**RE: Sunset Subdivision, Reconfigured Lot 30-P1
Drainage Calculation And Grading Plan for Reconfigured Lot 30-P1
Engineer's Stamp Date 7-1-2014 (File: K12D025)**

DATE: July 1, 2014
TO: Rita T. Harmon, P.E.
PROJECT: Sunset Subdivision
TOPIC: Response to Comments dated June 13, 2014

PAGE TITLE
Lot 30-P1 Grading Plan

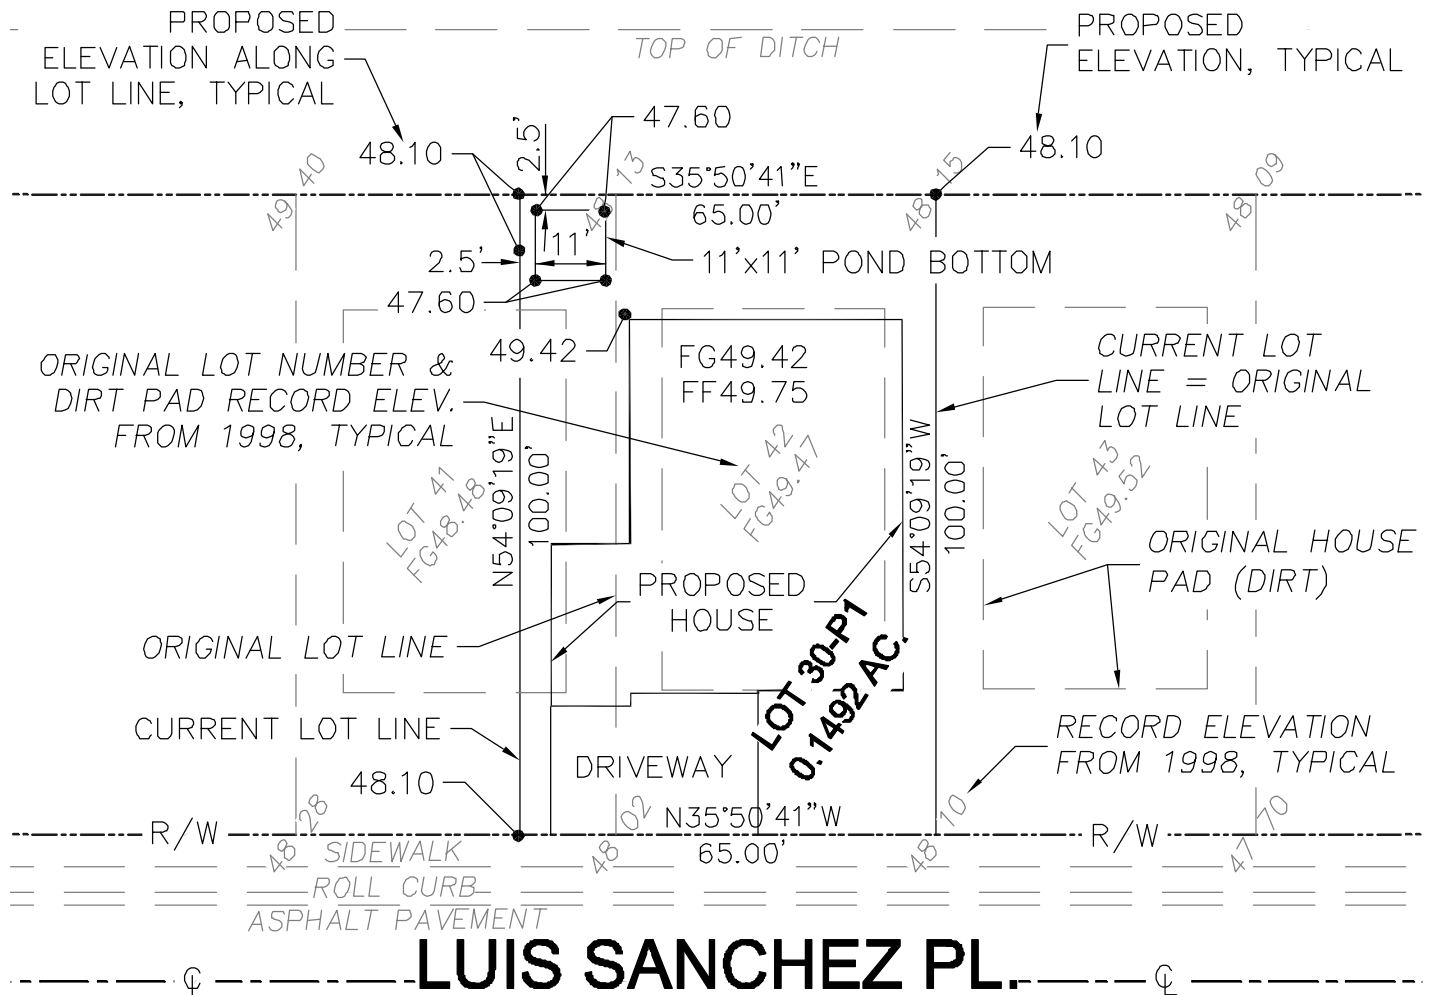
Based upon the information provided in your submittal received 7-14-2014, the above referenced Grading and Drainage Plan is approved for Building Permit. Please note that the approval is only for Lot 30-P1. All other lots will have to apply individually for building permits.

1. Please find attached a Grading Plan for Lot 3-P1 with existing elevations indicated per the as-built plan, and proposed spot elevations indicated at the lot corners, the Finished Floor, and the new pond. Please note the proposed spot elevations for the lot corners and the Finished Floor are identical with the original design.
2. We have designed the new pond to be more distinct, as requested.
3. The lot size is 65' x 100'. The allowable impervious area (per the original design) is 45% of the lot area. Thus the allowable impervious area, without providing additional ponding, is 45% x 6500 sf = 2925 sf. However, the proposed impervious area (house and driveway) is 3479 sf. Therefore additional ponding volume will be provided for the additional 554 sf (=0.0127 ac).

This area used to be Treatment Type B as originally computed, but will now be Treatment Type D. Following the same calculation procedure as in the original report, the additional volume required will be:

$$\begin{aligned} V_{\text{REQUIRED}} &= A * (E_D - E_B) \\ &= 0.0127 \text{ ac} * (1.97'' - 0.67'') * 3630 \text{ ft}^3/\text{ac-inch} \\ &= 60 \text{ cu. ft.} \end{aligned}$$

$$V_{\text{PROVIDED}} = 11' * 11' * 0.5' = 60.5 \text{ cu. ft.}$$

The computed volume is the additional volume provided beneath the original pond bottom elevation 48.10. The computed volume does not include the additional volume provided in the pond side slopes, and is therefore conservative.
